V3_Drainage Letter_COMMENTS.pdf Markup Summary

PCD File No. PPR2512

Letter Type – Drainage Report

5935 Templeton Gap Road
Office Renovation

SITE MAP / DRAINAGE PLAN FOR 5935 TEMPLETON GAP ROAD

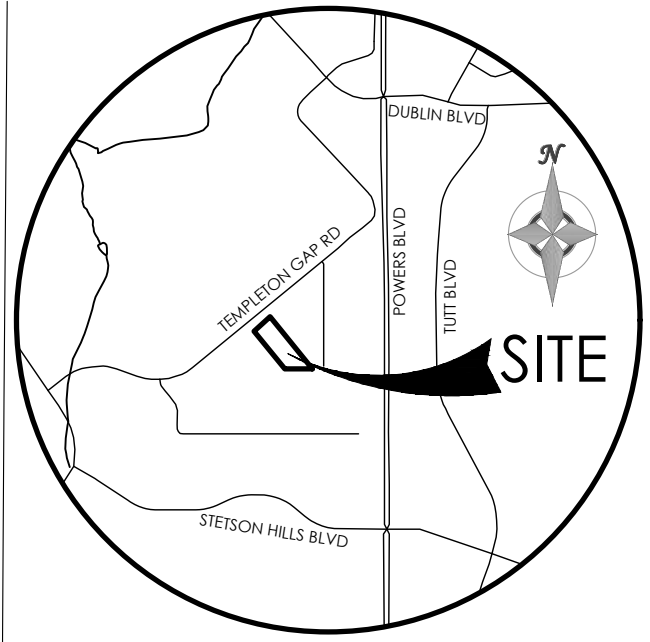
Typical drainage maps are required with existing (historical) vs. proposed (current) with basins and design points and flow summaries.

A full FDR is not required for this application but standard drainage report elements must still be included in the report and maps.

Although there are no changes to the drainage patterns proposed, the existing condition of the site was never approved or analyzed.
